DOCUMENT NO. RHO-RE-EV-11

THE DRY WELL FREQUENCY RESPONSE EQUATION: A CRITICAL REVIEW
OF ITS BASIS AND DERIVATION

Review Committee Members

October 1982

FIGURE 2. Volumetric and Geometric Relationships of Waste Tank Leaks.

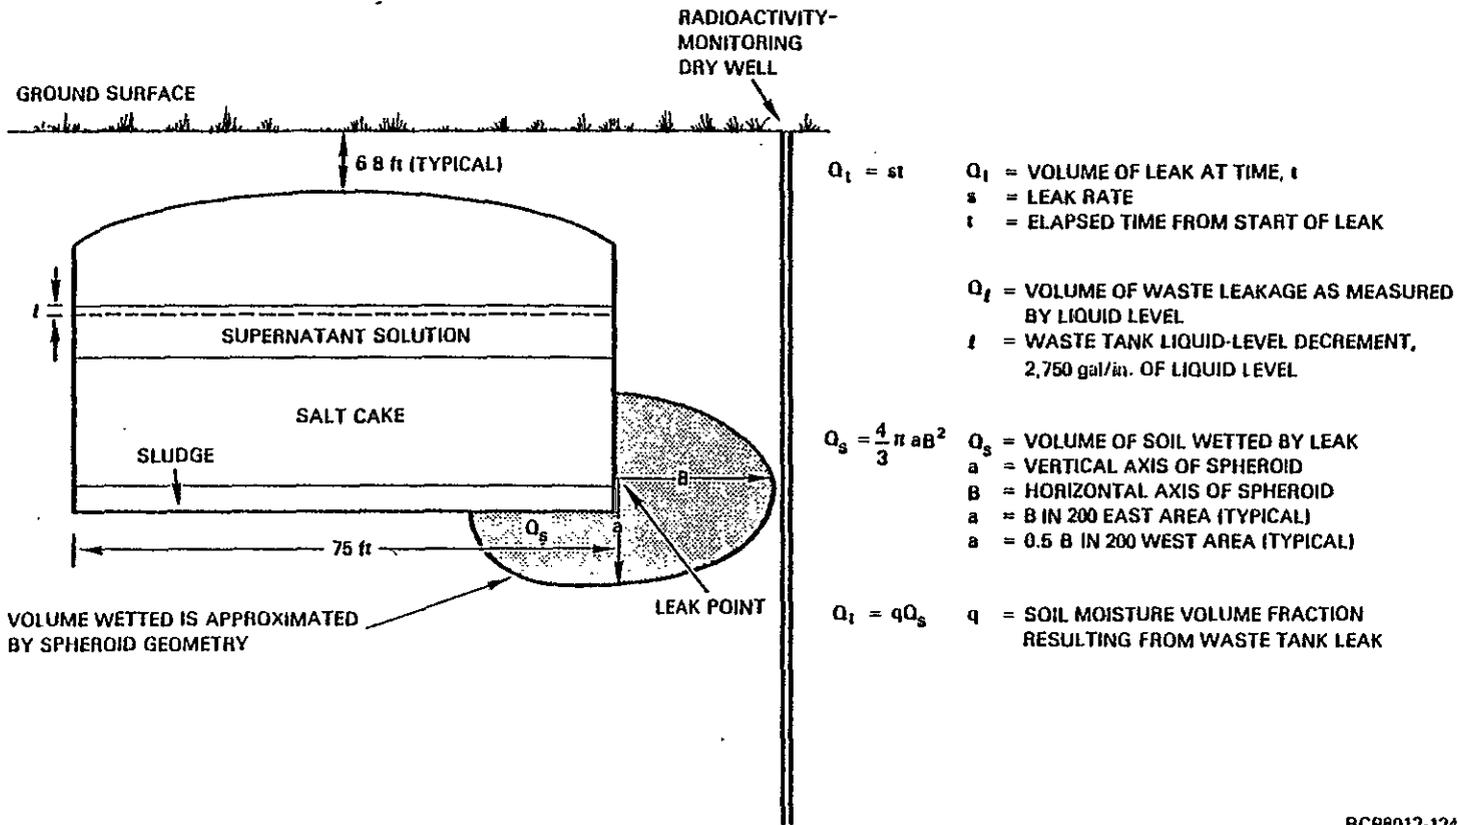
"The illustration on page 6 (Figure 1) needs to be redrawn to assure dimensions a and b are more representatively illustrated."

Correction made in final report. See Figure 2.
